Plate Cylinder Shaft Alignment Bearing Upgrade

for the Stolle Rutherford Decorator

Stolle
Rutherford Decorator
Technical Update 1207-2

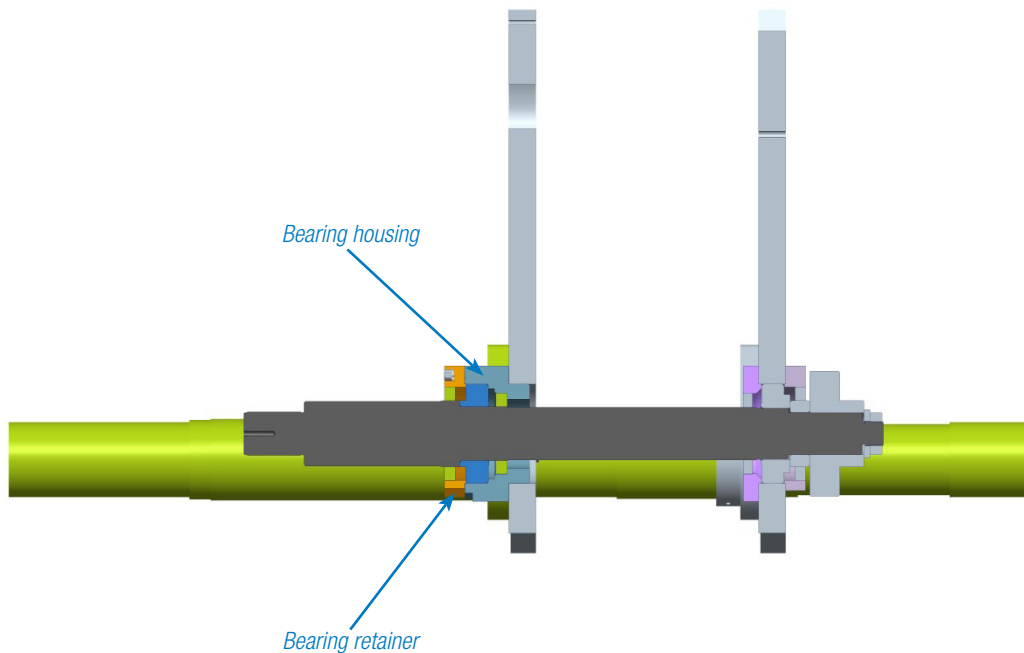
Stolle has developed an upgrade kit for the Rutherford ink station that allows for the adjustment and setting of the plate cylinder shaft alignment. This kit consists of a new front bearing housing, bearing, seals and bearing retainer.

The installation of the kit allows for plate cylinder alignment (toe-in) to be adjusted while keeping the inker frames square and locked in position. The housing can be adjusted in the bore in the center frame and pinned once the final settings are achieved. This serves to increase the life of the shafts and bearings (or bushings) throughout the inker by maintaining correct shaft alignment through the three frames.

The Plate Cylinder Shaft Alignment Bearing upgrade kit (part # 6CD6-A-468) is available for all Stolle Rutherford Decorators printing cans 500ml or smaller. Kits for other can sizes are available upon request.
